From: Priscilla Burton
To: Mark Reynolds
CC: Helfrich, Joe; Nance, Angela
Date: 5/14/2008 5:10 PM
Subject: Hiawatha Technical Inspection Report
Attachments: insp rpt 1621 map_20080507155127.pdf; Insp Rpt 1621_20080512131002.pdf

HIAWATHA PROCESSING PLANT
 AND WASTE DISPOSAL SITES
 Ex. V-13

Inspection Report

RE: Soil Cover Depth Evaluation. Phase I Bond Release Slurry Pond 4 and 5. Co-Op Mining Corporation, Hiawatha Mine, C/007/0011, Task 2895

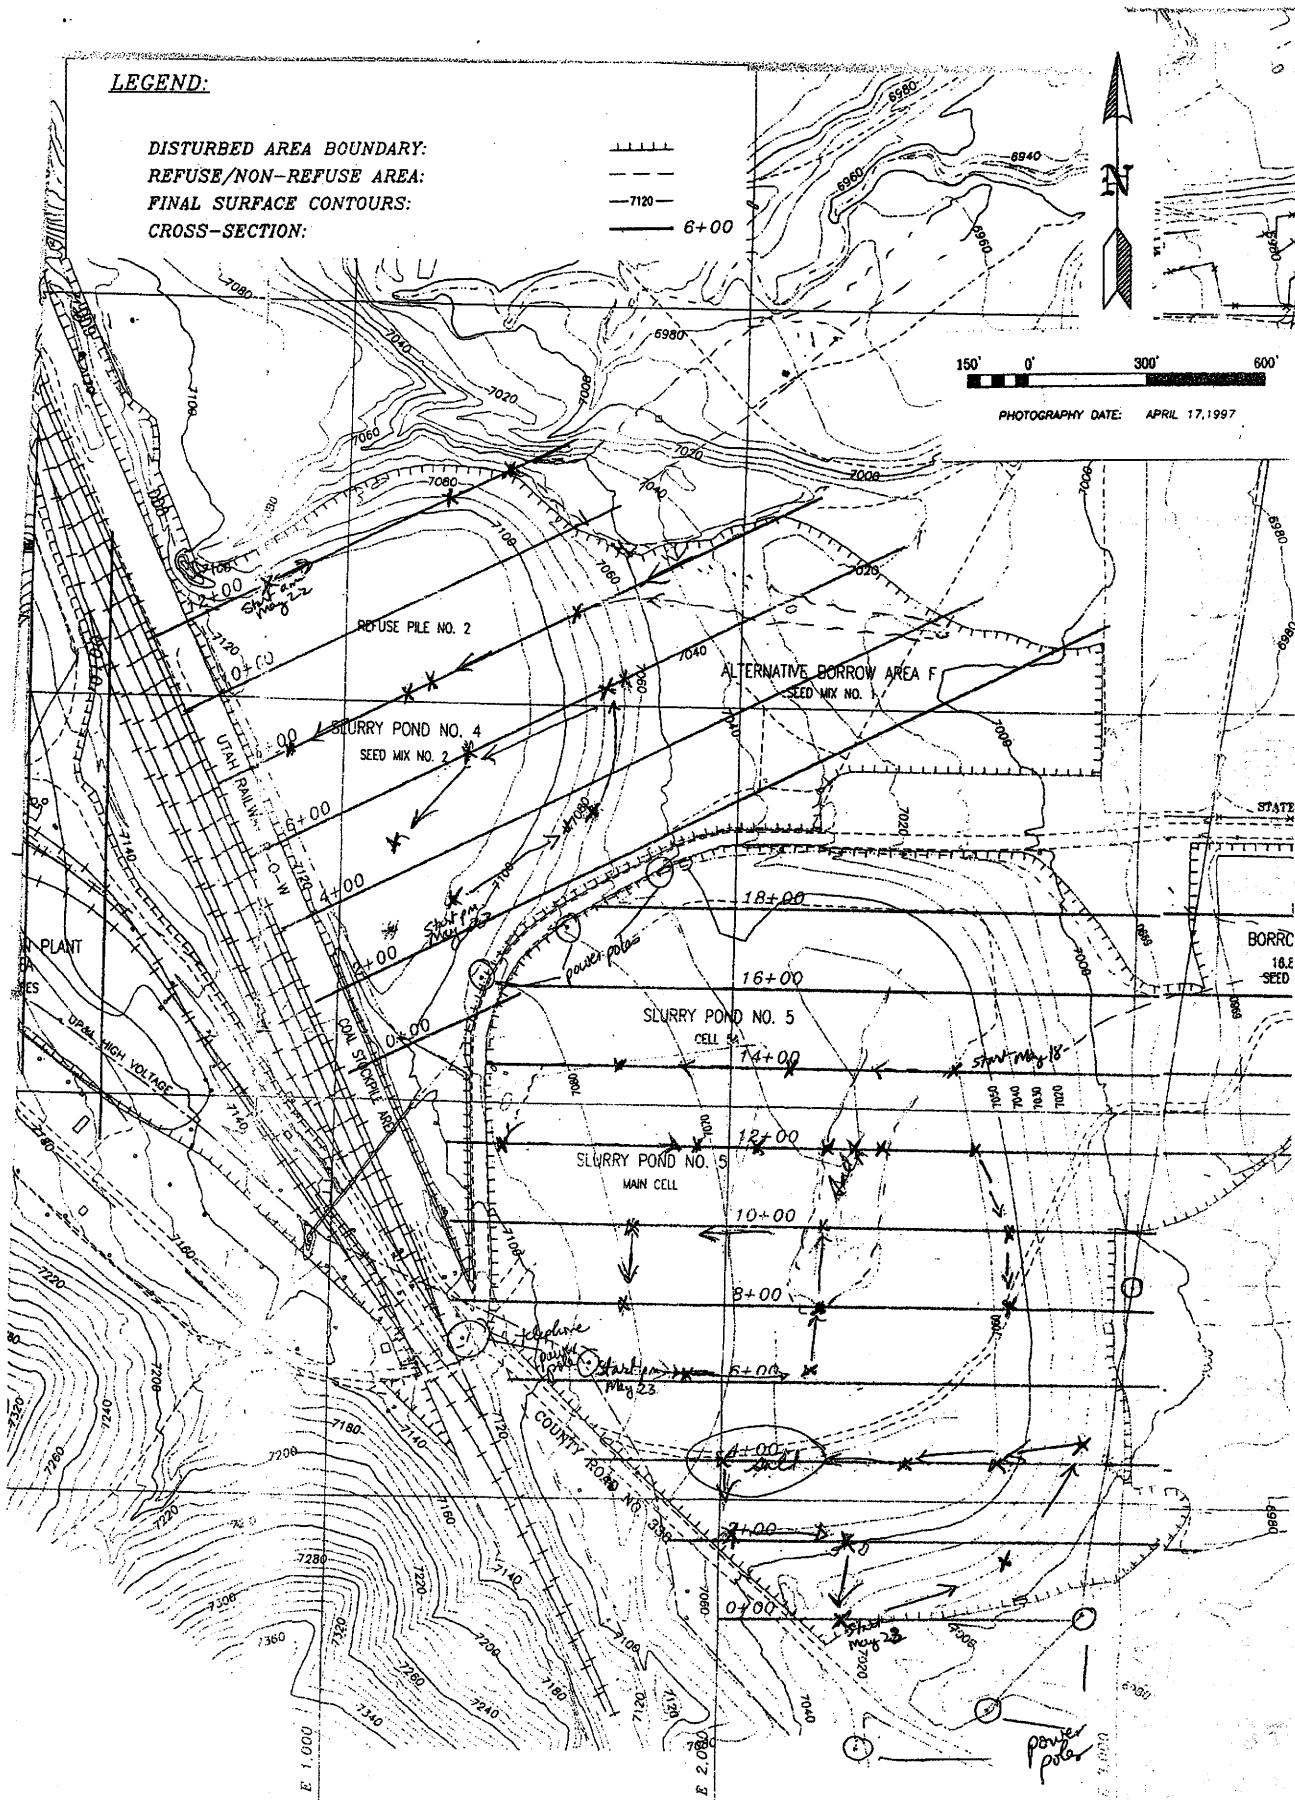
The average cover on Slurry Pond #5 was 15 inches. There are two areas of salt accumulation on the level surface of Slurry pond #5. These areas have less than the average cover and little drainage due to their position. I would like to return to the site to show you these areas and calculate their acreage using a gps unit.

The average on Slurry Pond #4 was 16 inches.

Notes were taken of 18 auger holes drilled into REFUSE PILE #5 at Stations identified on MRP Ex. V-13. Notes included location description, soil cover depth (inches), brief soil description, brief vegetation description. Photographs were taken. The complete notes are an attachment to this report and are also filed in the 2008/Internal file. The Refuse Pile #5 has an average of 15 inches cover depth over the mine waste, based upon 23 auger holes dug. The Slurry Pond #4/Refuse Pile #2 has an average of 16 inches of cover depth based upon the 11 auger holes dug.

I returned to Hiawatha to take measurements of the soil cover over the refuse in expectation of being asked to make a finding for the revised Phase 1 bond release application. Using Ex. V-13, I walked across the site and augered the soil cover, making notes on cover depth, moisture content, salt accumulation and total live cover in a 3 ft X 3 ft area around each soil auger site. Photographs were taken of most auger sites.

Summary for Refuse Pile #5: 15 inches cover depth was the average for the 23 auger holes dug.

Summary Slurry Pond #4/Refuse Pile #2, 16 inches is the average for the 11 auger holes dug.
